Application for Plan Review

Name of Project: Autochair LLC

Thank you for submitting the plans for the Change of Use. The plans have been carefully reviewed by a qualified code enforcement official to examine for full compliance with the North Carolina Fire Prevention Code and all other fire protection regulatory documents. There are some items that were found during the plan review process that need to be addressed before a final inspection of the new facility can be given. These items are outlined and described below.

Interior of 1168 W. Main
Auto Center LLC.

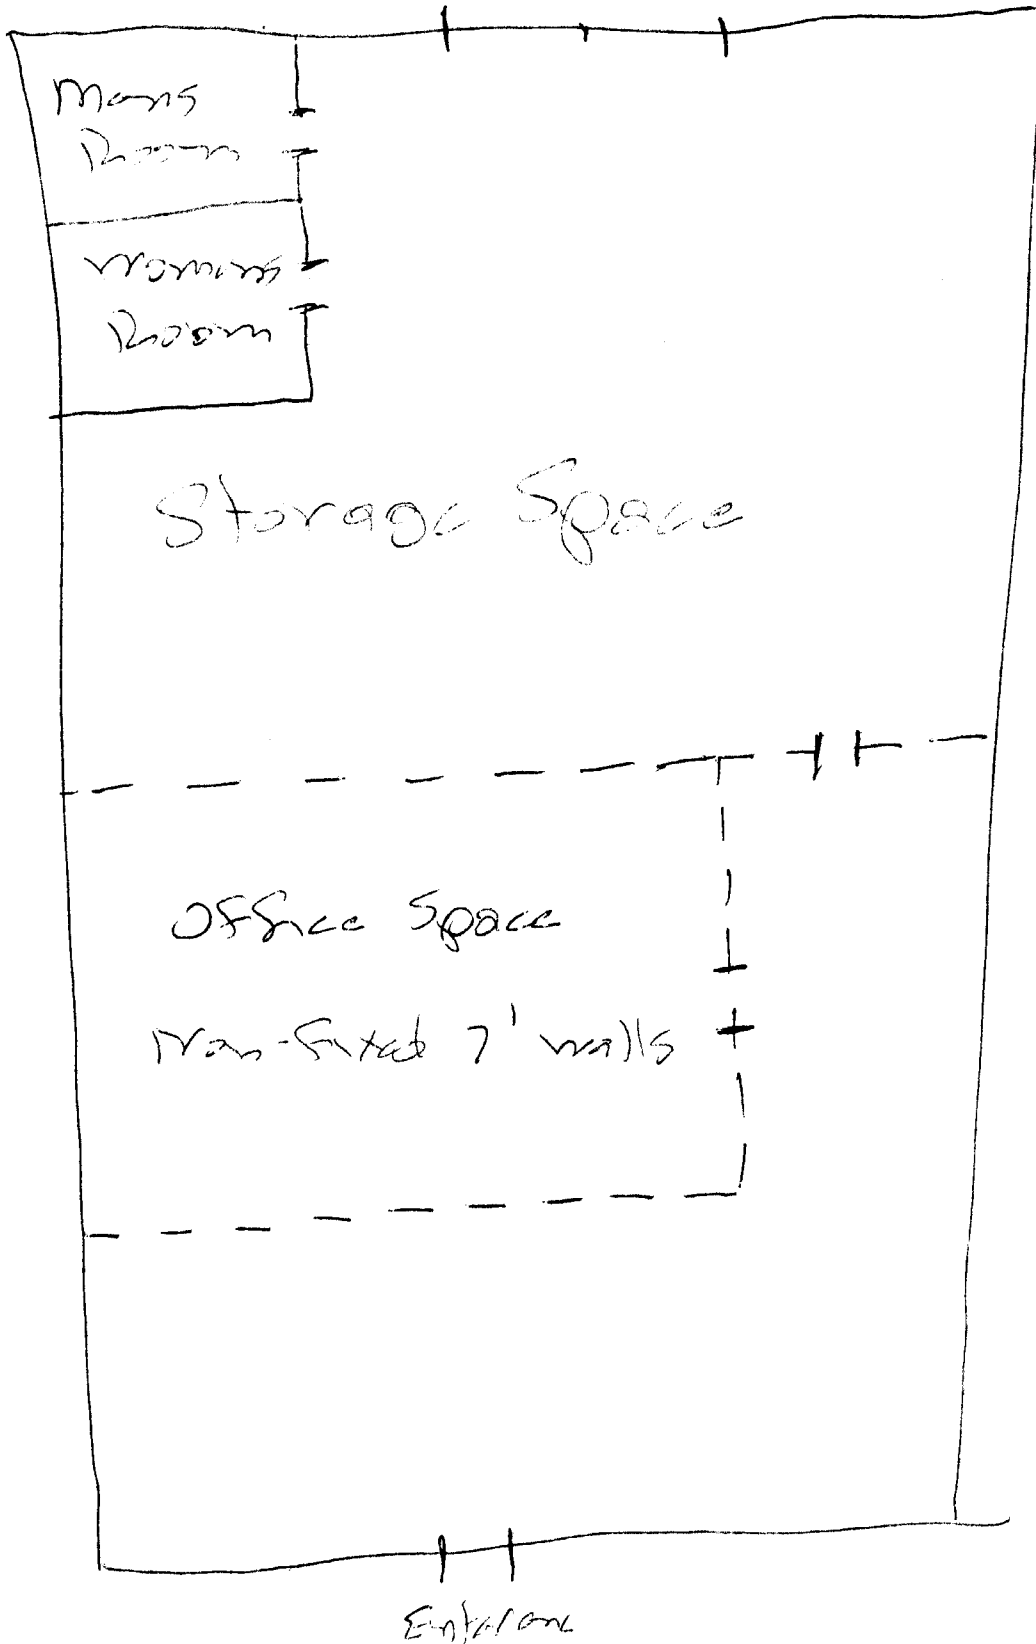
- **906.1 Fire Extinguishers**
 - Fire extinguishers shall be placed in approved locations as drawn by the code enforcement official on the approved plans.
 - The fire extinguishers provided shall have a minimum rating of 2A 10B:C and shall not be installed higher than 5 feet above the finished floor
